Meeting Agenda

Historic Zoning Commission

Monday, September 30, 2024

ALL WINDOWS AND DOORS
TO BE WOOD SDL UNLESS
NOTED OTHERWISE

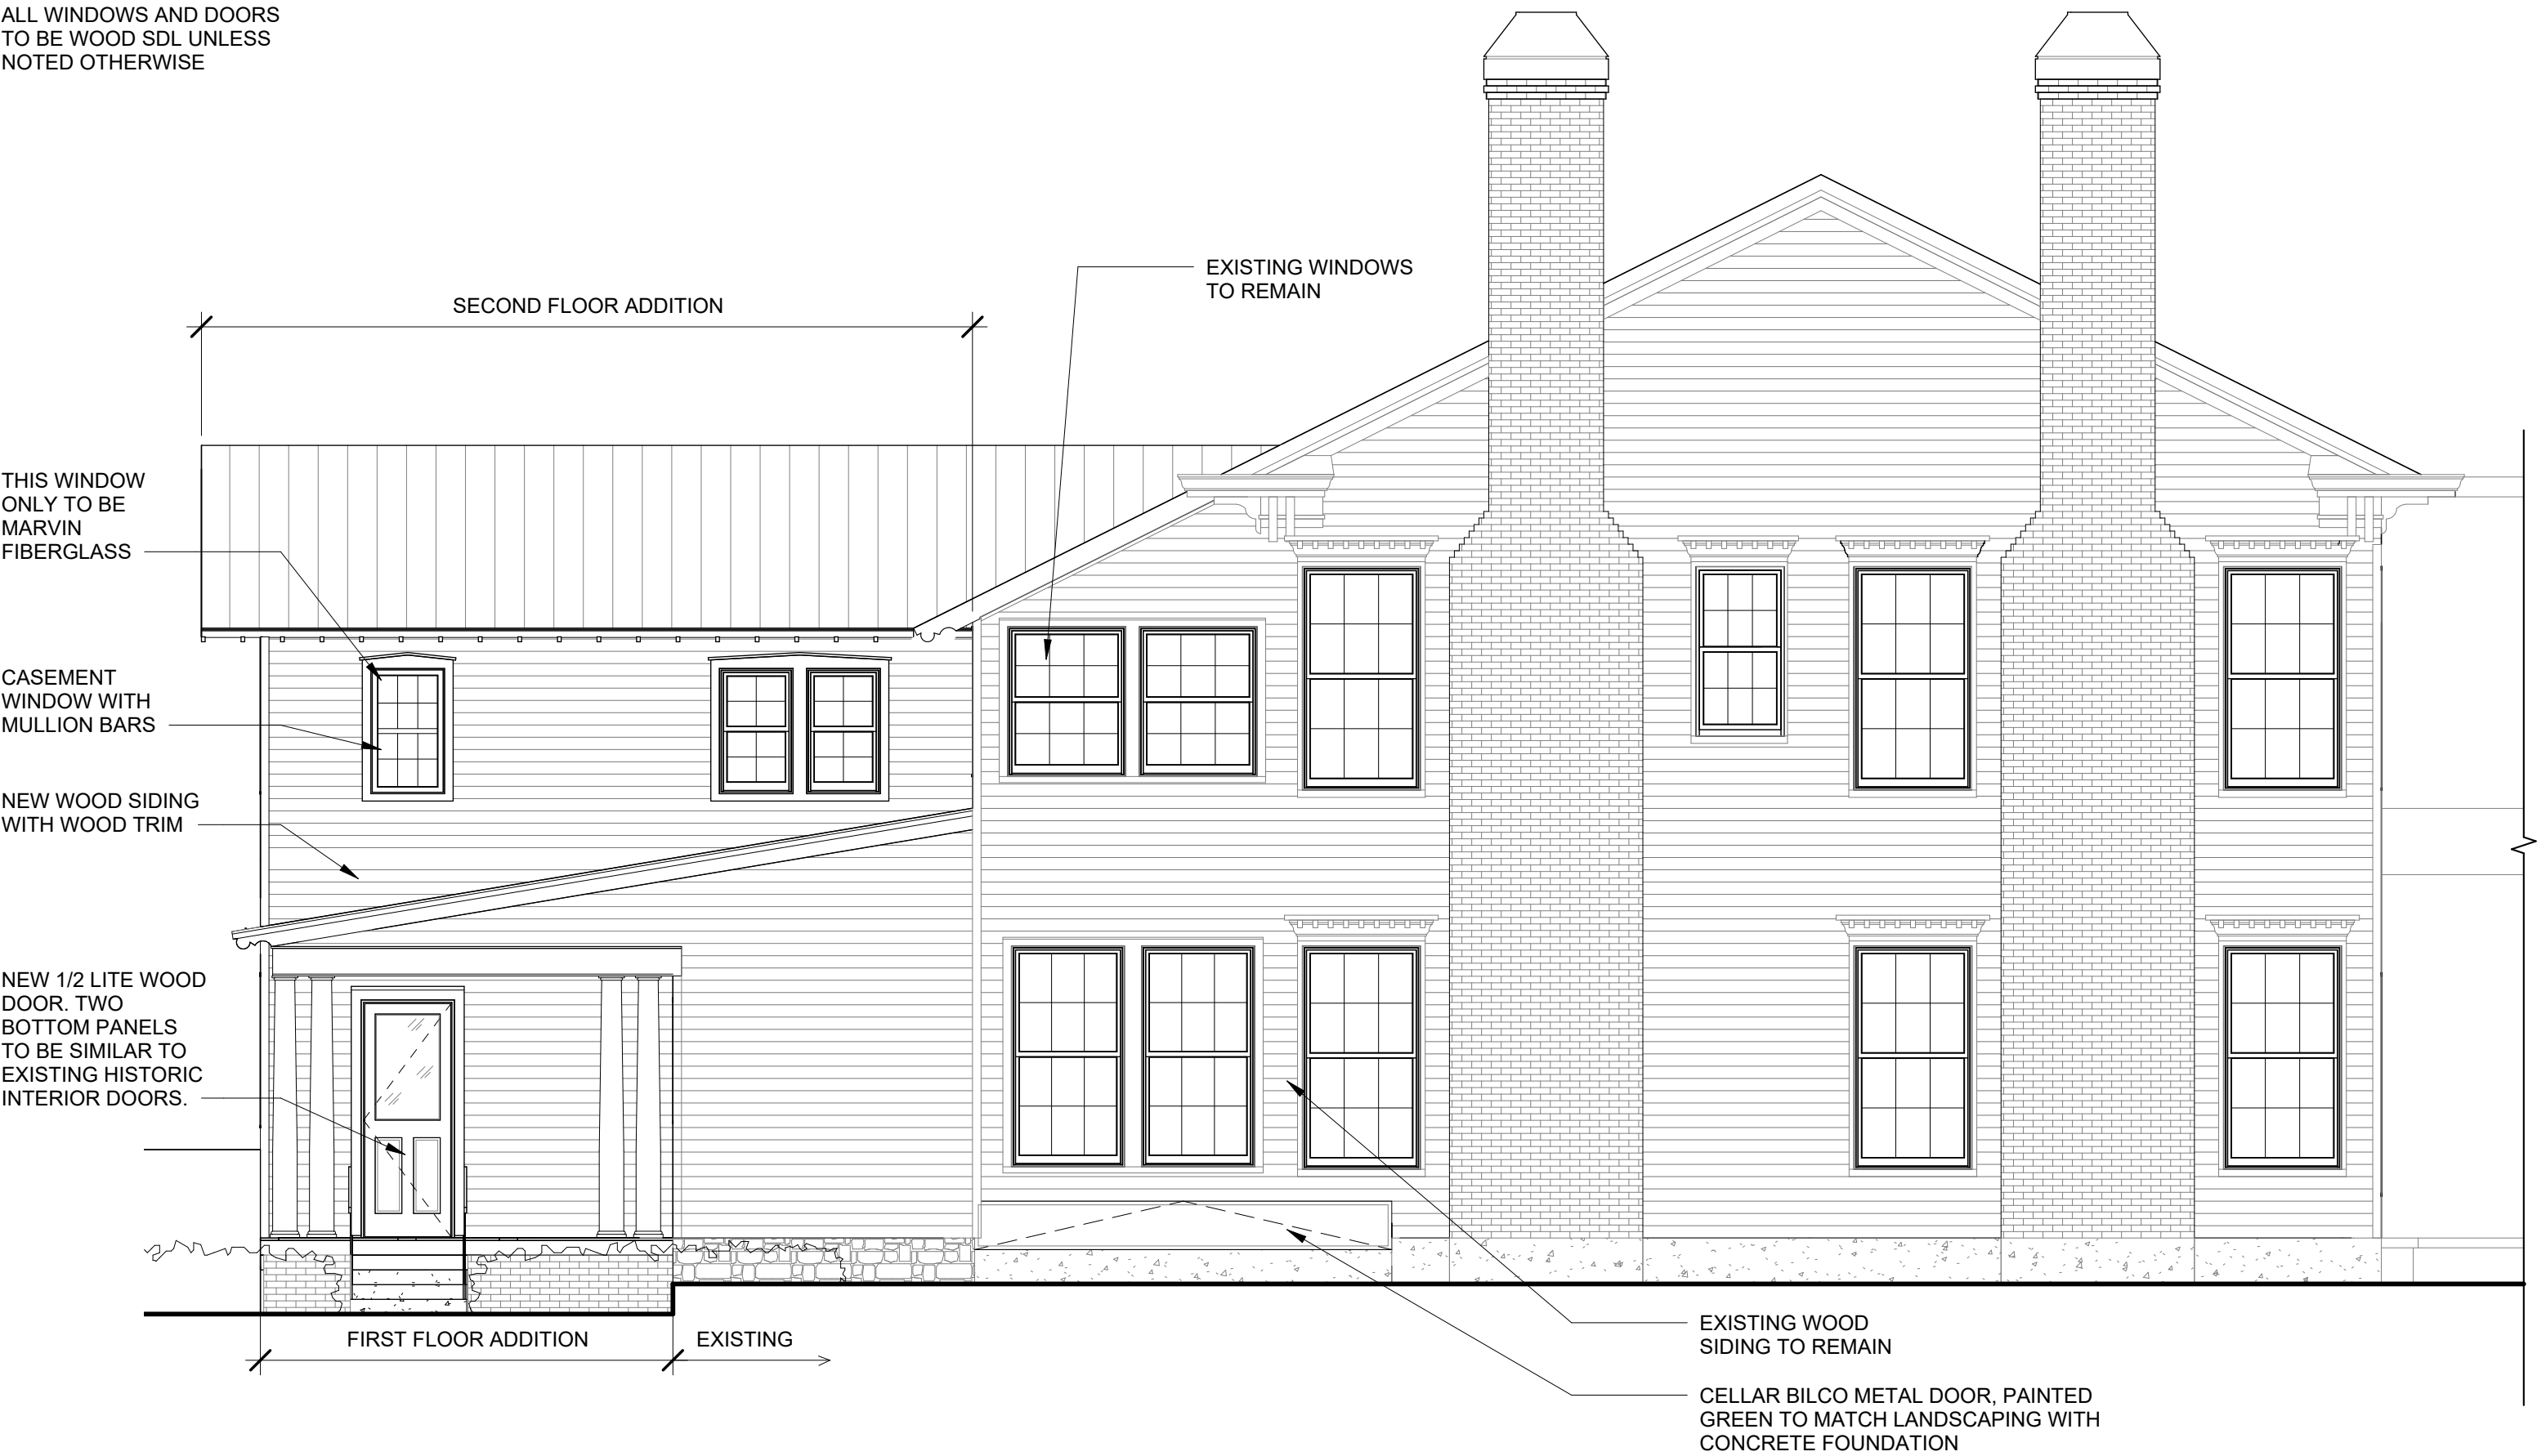
The proposed addition would add approximately 927 sq. ft. to the footprint of the home. The existing historic footprint of the home is 2,133 sq. ft. The addition is appropriately sized, being 43% of the historic footprint. The Guidelines recommend that additions be subordinate to the historic building and should not exceed 50% of the historic building's footprint. The addition, along with all of the structures, equates to a total lot coverage amount of 0.02%. This is appropriate as the Guidelines recommend not to exceed 35% of lot coverage. The orientation, form, and size of the addition that is being proposed are appropriate.

The rhythm and placement are traditional and provide continued symmetry that is typical to the neoclassical style. The windows are more compatible in size and detailing to those on the historic building.

1. Window specifications showing three-dimensional cut-outs with dimensions must be provided to the Preservation Planner before the Building Permit submittal.
2. The reveal of the siding on the addition must match the existing siding on the building.
3. The application must meet all the requirements of the City of Franklin prior to issuance of a building permit.
4. Any additional changes to the approved plans must be returned to the Preservation Planner or the Historic Zoning Commission for review and approval.

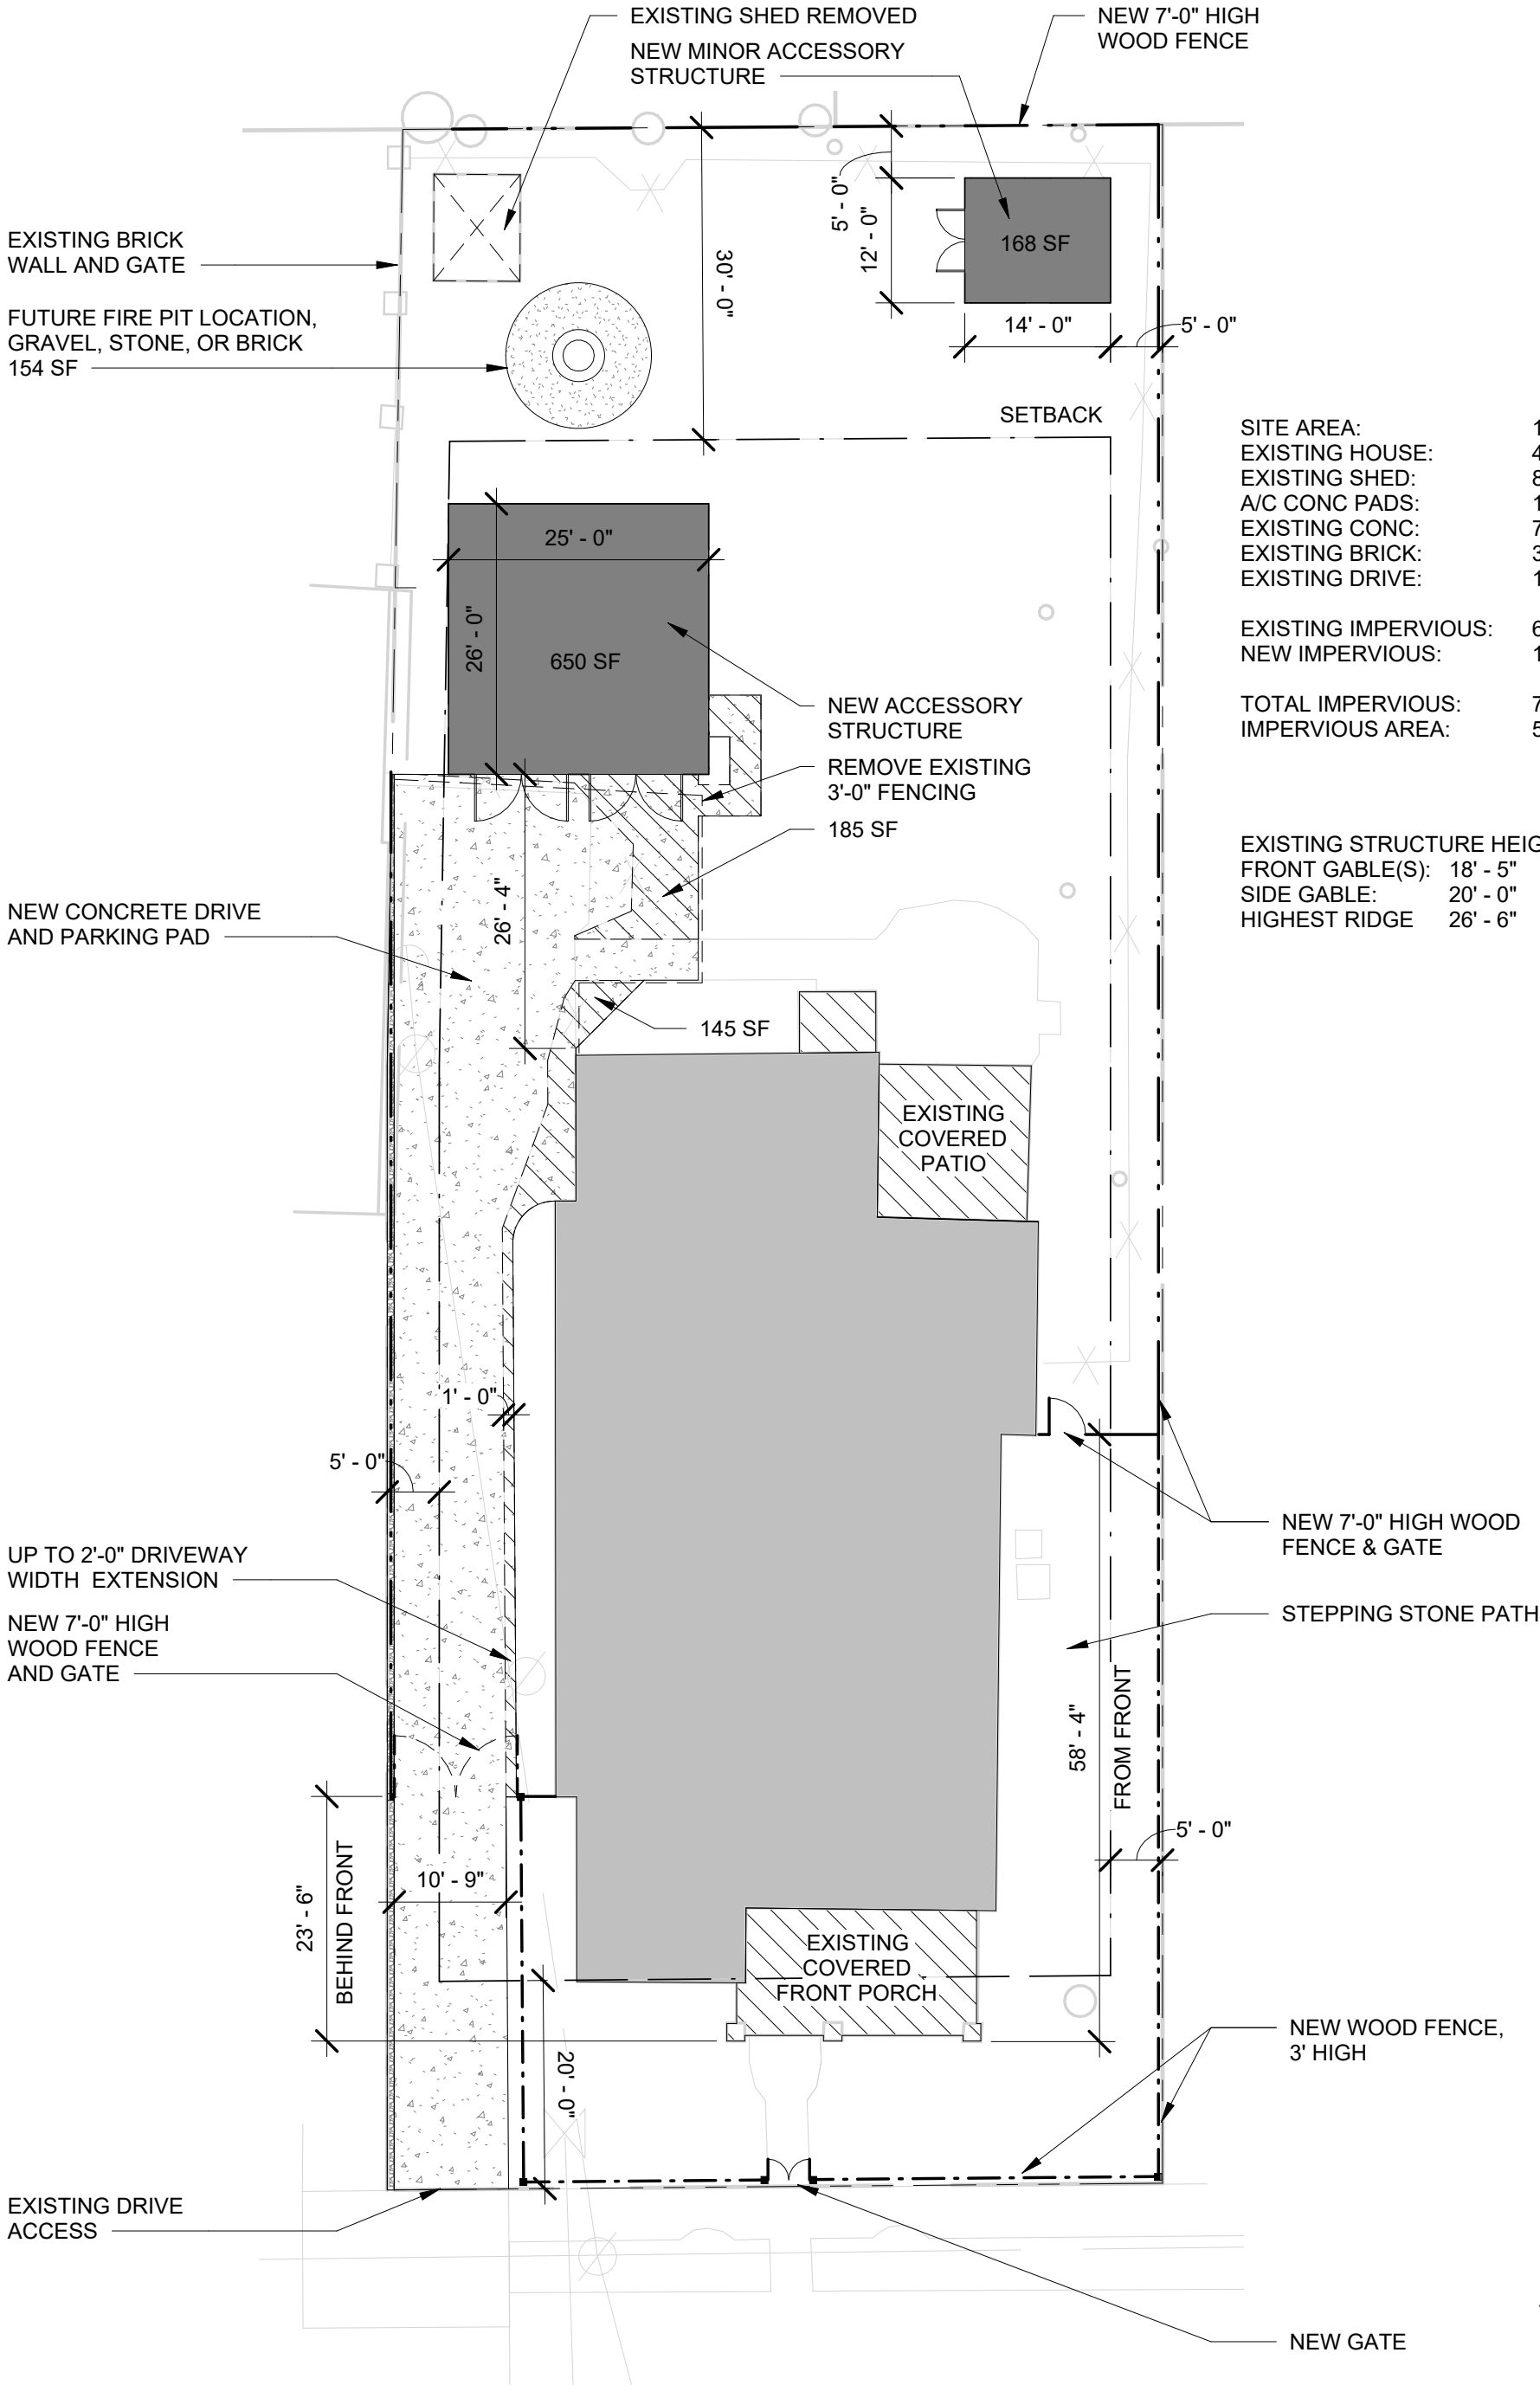
Based on the 1928 Sanborn map, the proposed new accessory structure is in the same place as the historic accessory structure that was located on the site and aligns with the placement

recommendations of the Guidelines. The scale, massing, and height are all subordinate to the principal building, and it supports the character of the house.

1. The windows on the accessory structure must have a historic profile and dimensions and consist of either wood or a composite material with the appearance of wood. The window and garage door specifications must be approved by the Preservation Planner or the HZC prior to the issuance of a building permit.
2. The siding exposure on the larger accessory structure must match the principal building's exposure.
3. The application must meet all the requirements of the City of Franklin prior to issuance of a building permit.
4. Any additional changes to the approved plans must be returned to the Preservation Planner or the Historic Zoning Commission for review and approval.
